Advisory Design Panel Meeting  
AGENDA

**REPORT DATE:** October 29, 2024      **MEETING DATE:** November 13, 2024  
**TO:** Advisory Design Panel  
**FROM:** Colin O’Byrne, Manager of Planning  
**SUBJECT:** Development Permit Application for 19516 Hammond Rd

19516 Hammond Road

**SITE PLAN**  
SCALE: 1/8" = 1'-0"

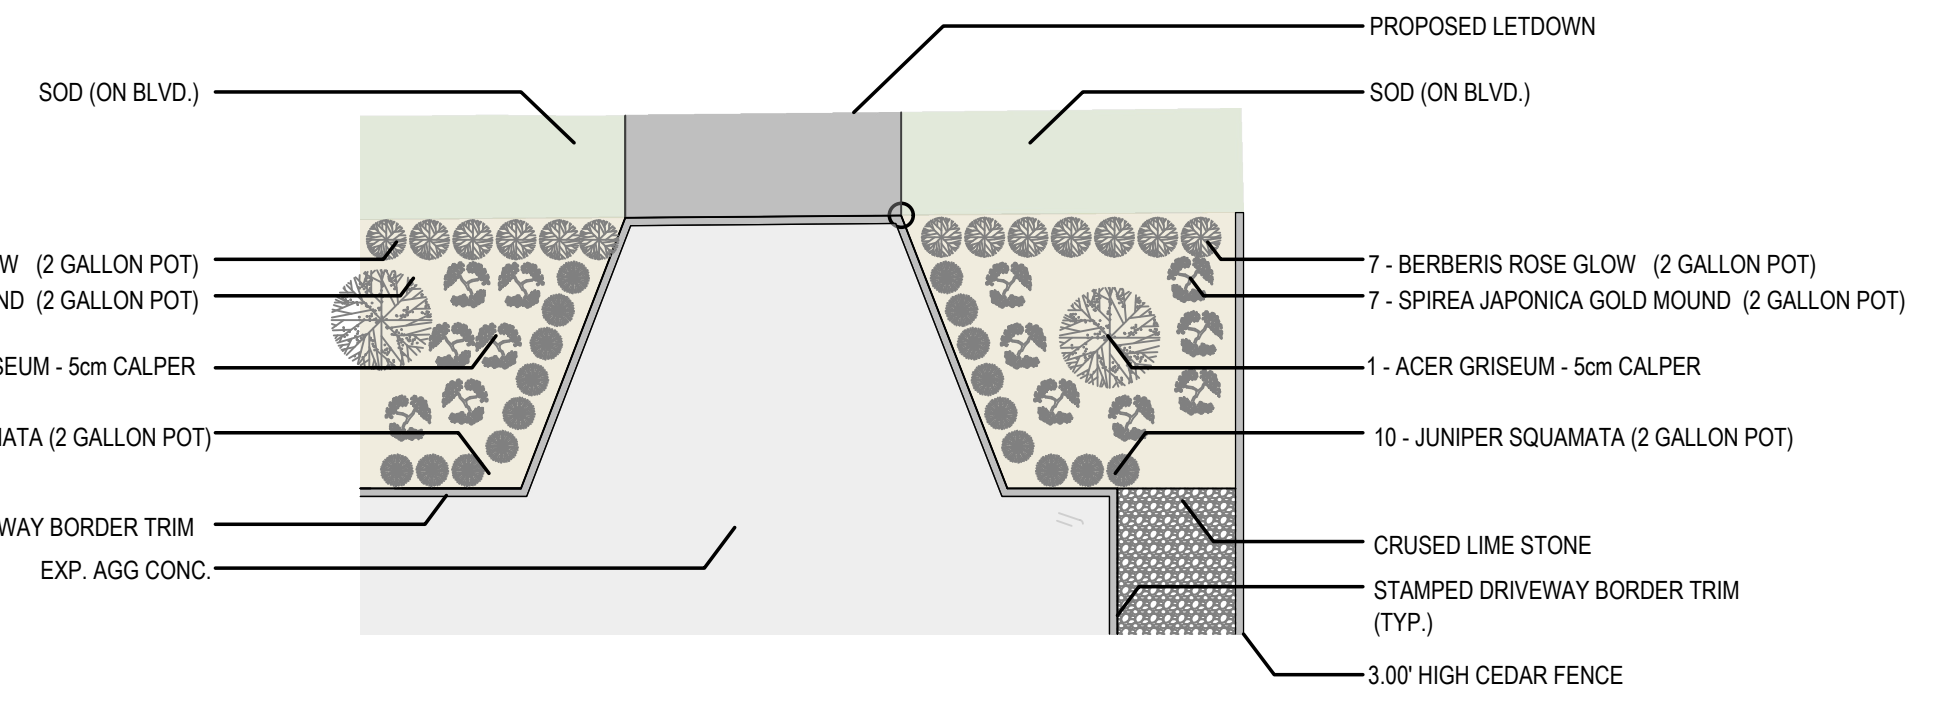
Suggestion for the developer to consider creating two driveway let downs to mitigate any safety concerns relating to blind spots and consider adding landscape down centre of the driveway between the middle units to achieve curb appeal (The Applicant was in support of these revisions and recommendations);	<p>The design was revised to show two driveways with additional landscaping.</p> <p>The driveway design has been revised to incorporate a stamped border trim.</p> <p><i>Staff note: The DPA guidelines and Provincial Active Transportation Design Guidelines do not support multiple driveways because this creates additional points of potential conflict between vehicles and people using sidewalks and bicycle lanes. Additionally, frequent driveway let-downs negatively impact the comfort of people using mobility aids and reduce street parking availability. Lastly, narrower driveway entrances decrease sightlines when taking into account vehicles parked along the curb.</i></p>

The ADP is requested to consider the revised plans and provide any additional comments, along with a recommendation to Council. As noted in the table above, staff recommend a single driveway to align with the DPA guidelines and the Province’s Active Transportation Design Guidelines. The ADP is requested to provide design suggestions for improving the functionality and design of the front landscaping for a single driveway access layout.

**SHED PLAN**

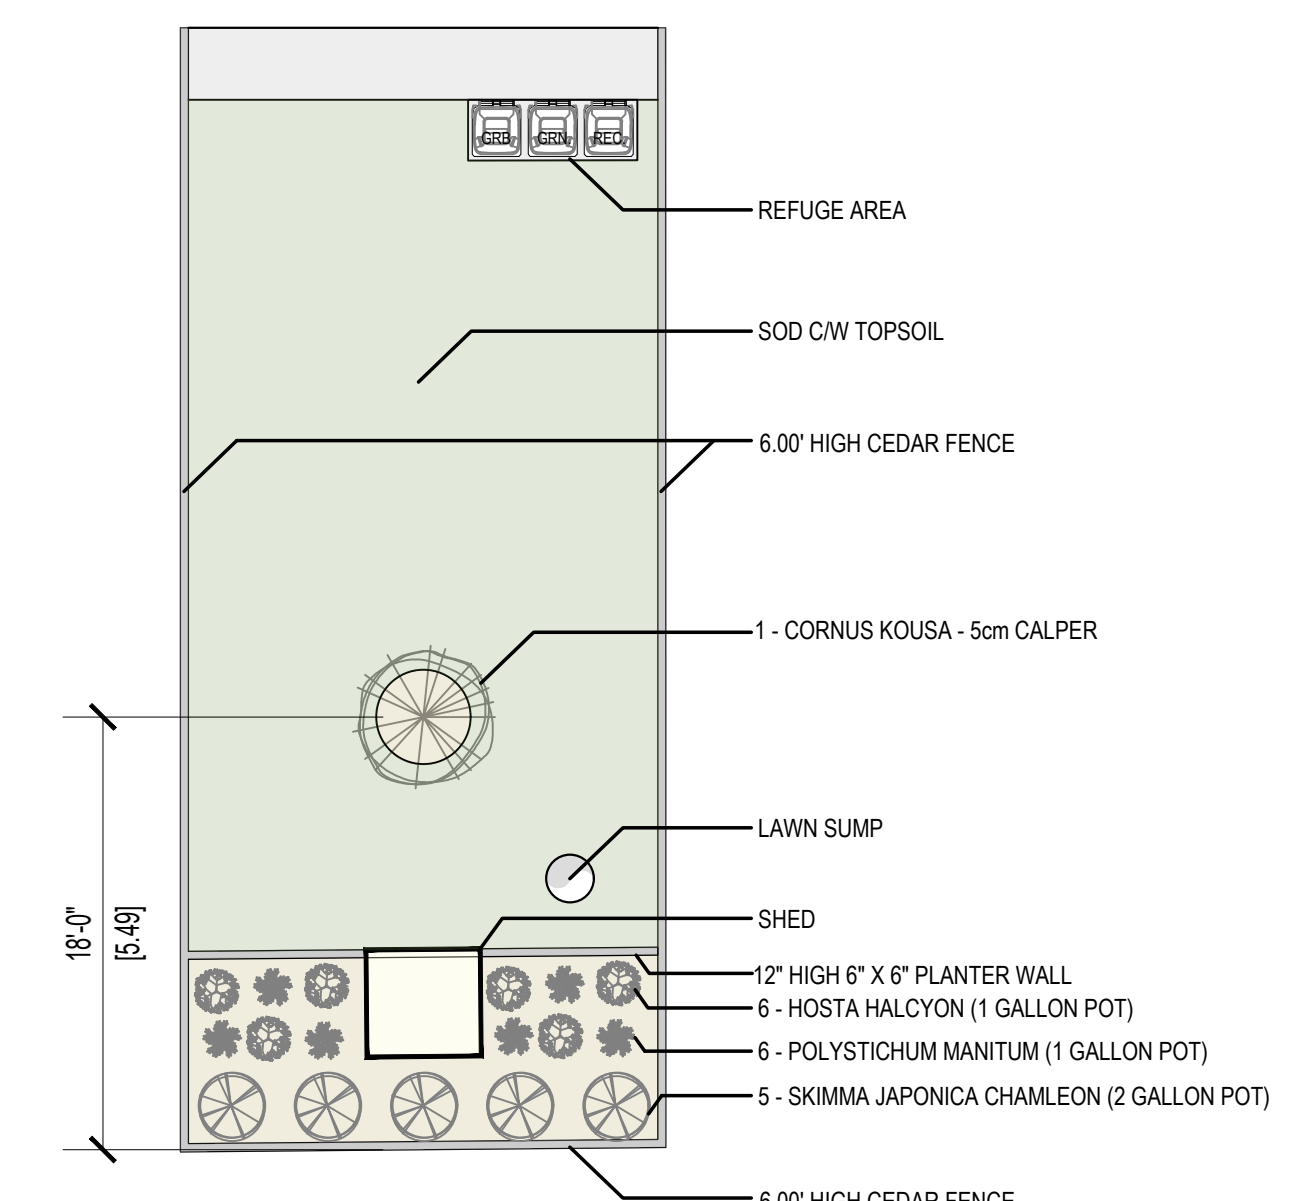
<p>Other design changes to address design guideline requirements</p>	<p>Each unit now has a dedicated area in the backyard for city recycling/garbage/compost bins.</p> <p>Each unit now has a garden shed added in the back of the property to add extra storage space.</p> <p>Applicant confirmed that adding a fence to the edge of the lower deck to the lower suite access in order to create a more personal space had been considered but removed in order to maintain access to the middle units and the bike storage.</p>
--	---

**NORTH ELEVATION**

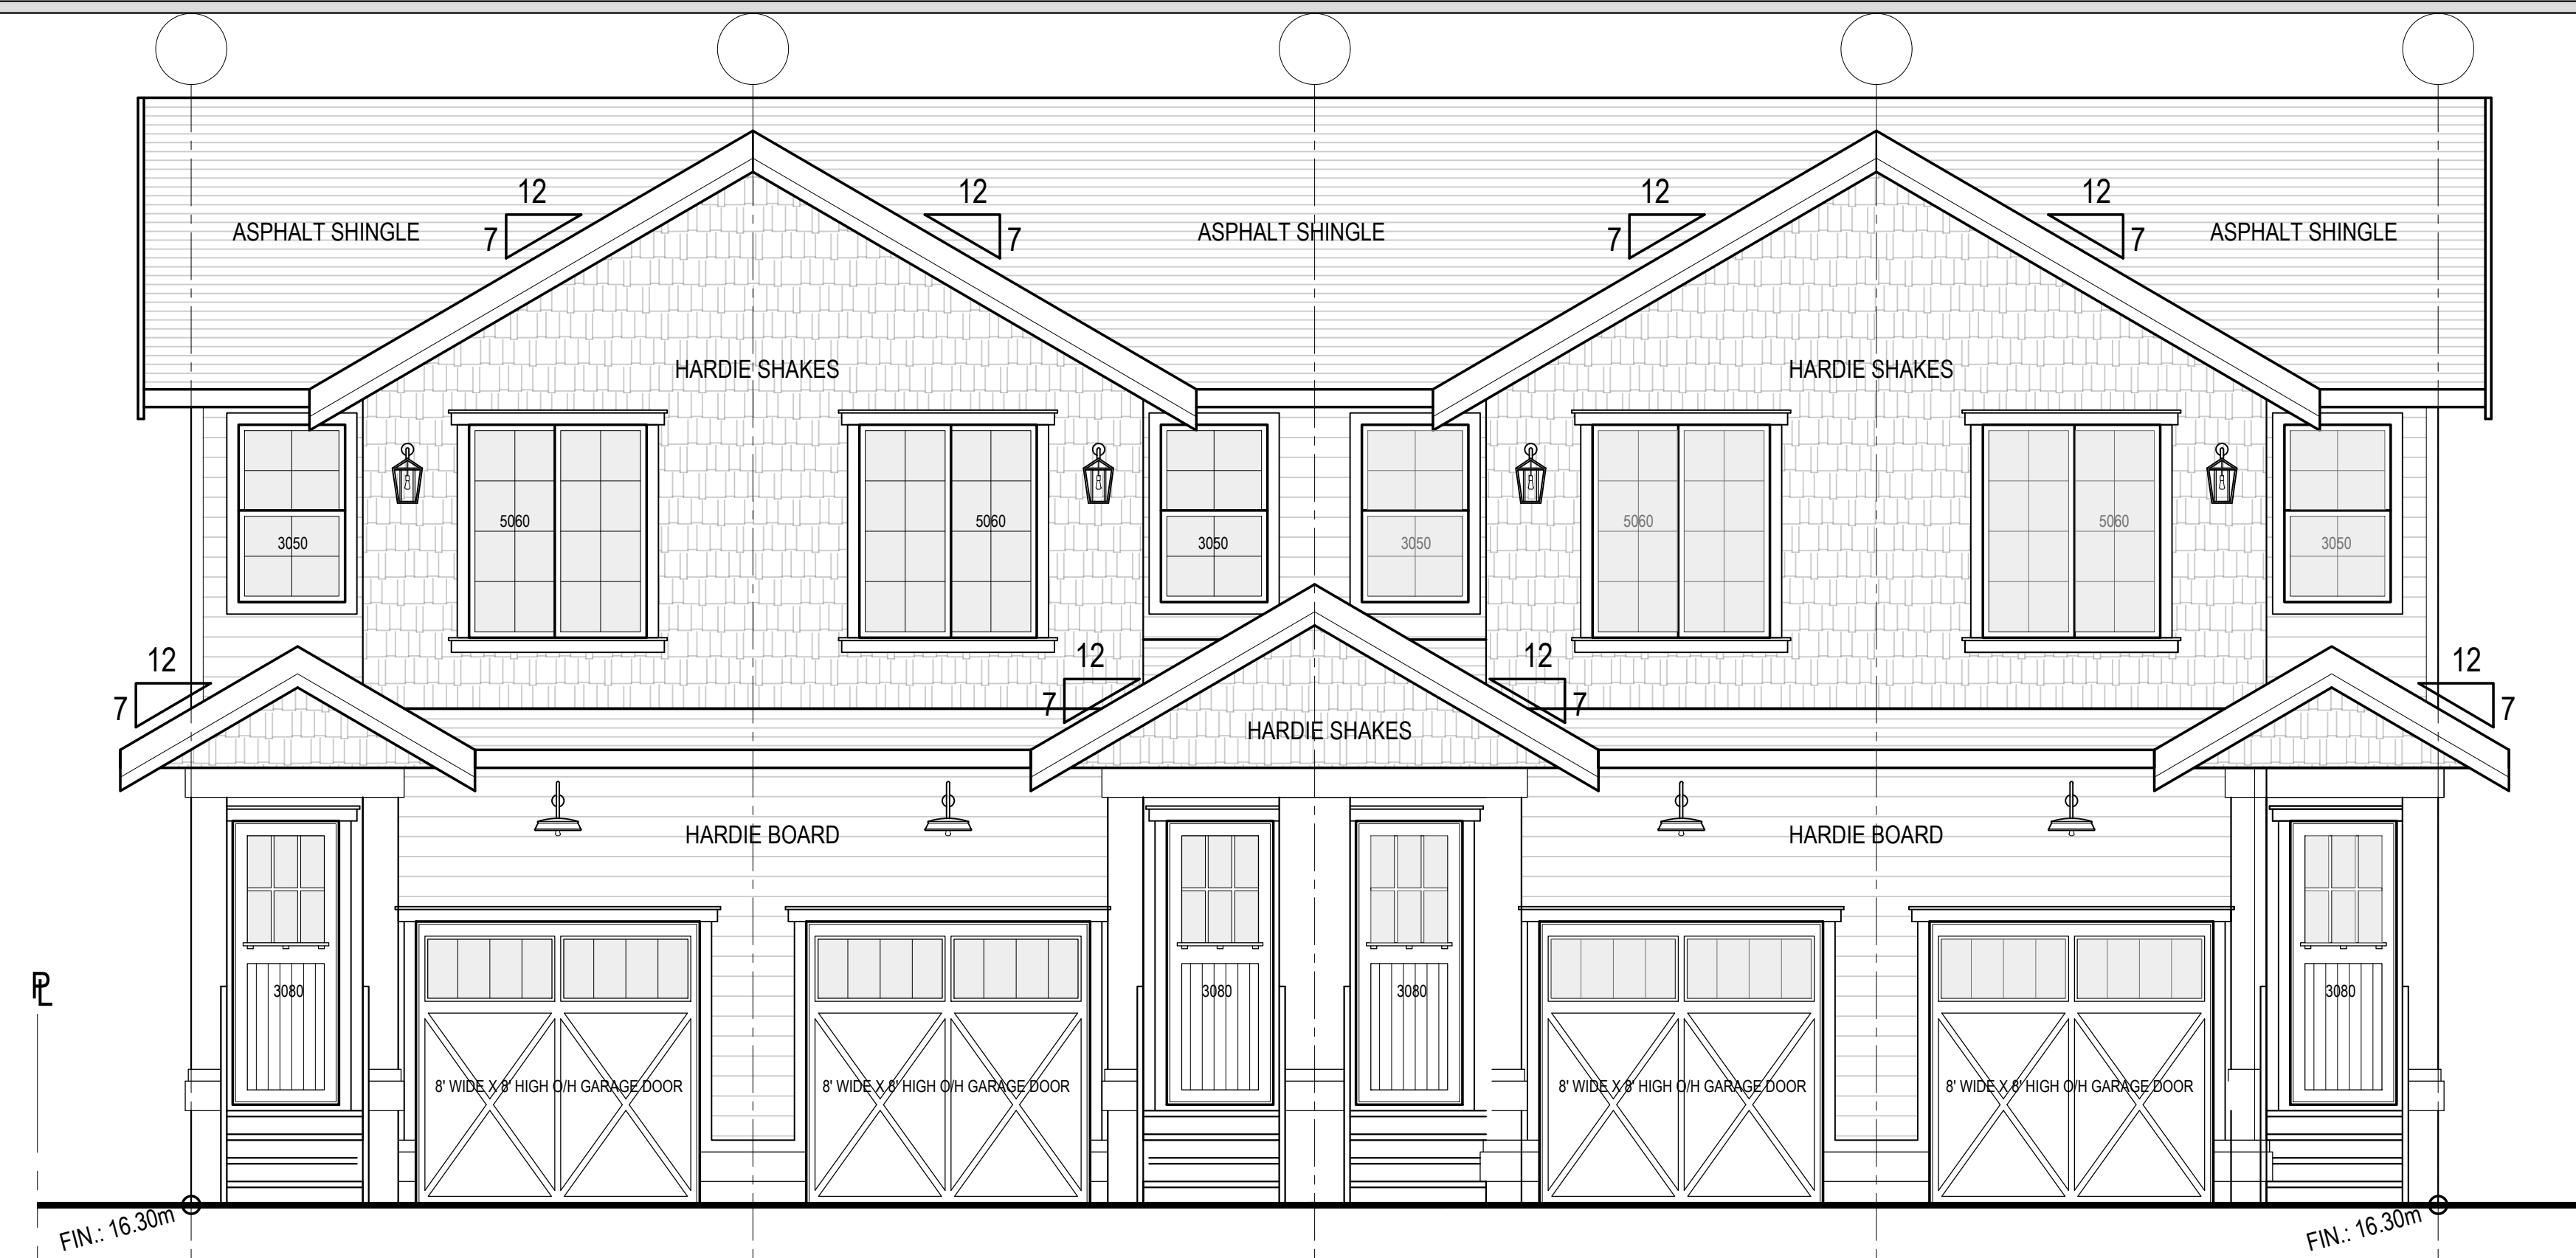
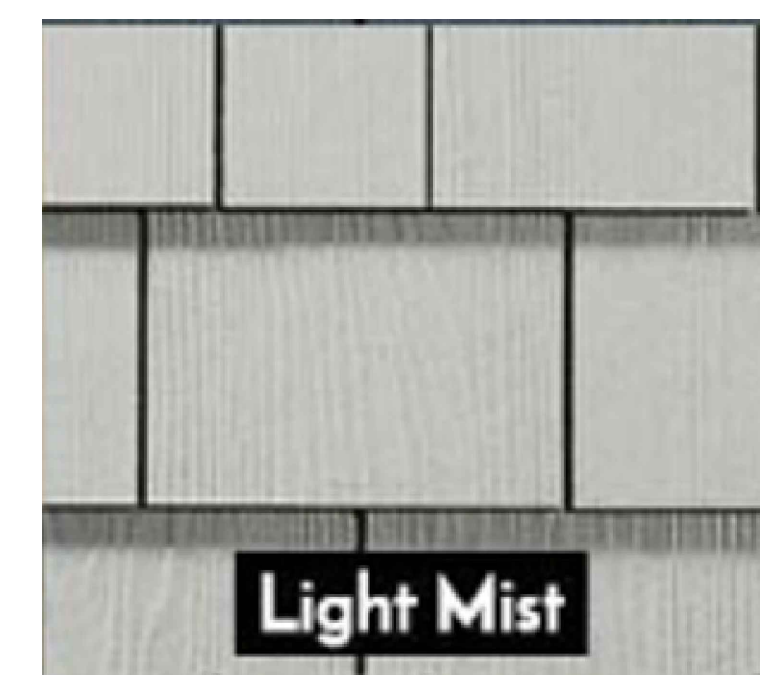
The suggestion was made for the addition of a small roof overhang to support the secondary street address signs;	An address sign has been placed on the front of the building for the secondary suite.
Clarification questions were asked regarding the front elevations requesting clarity on cladding materials (Applicant 1 confirmed	Clarification was added to the drawing regarding cladding on the side of the building.

that the front of the home would be cladded in hardy board);	
Comments were made around the deteriorating retaining wall in the rear of the property;	The existing 'rock wall' (9" high) has been removed from the plans for clarity.
The request was made for more details to be provided on the proposed fencing including the type of material, height, and length for the site;	The location and size of fencing has been updated.
A recommendation to expand the window wells in the suites at the rear and provide more patio space for the units further recommending reducing the width of the stairs to the upper unit to provide more natural light into the lower suites;	The steps leading to the upper patios have been reduced in size to allow more natural light into the lower patio area.
The request was made for confirmation of the size of the rear patios as there was a discrepancy in the site plans attached (The Applicant confirmed that the images on page five were correct dimensions of the patio size);	Clarification has been added to the drawings regarding the size of the back patios as they relate to the overall building dimension.
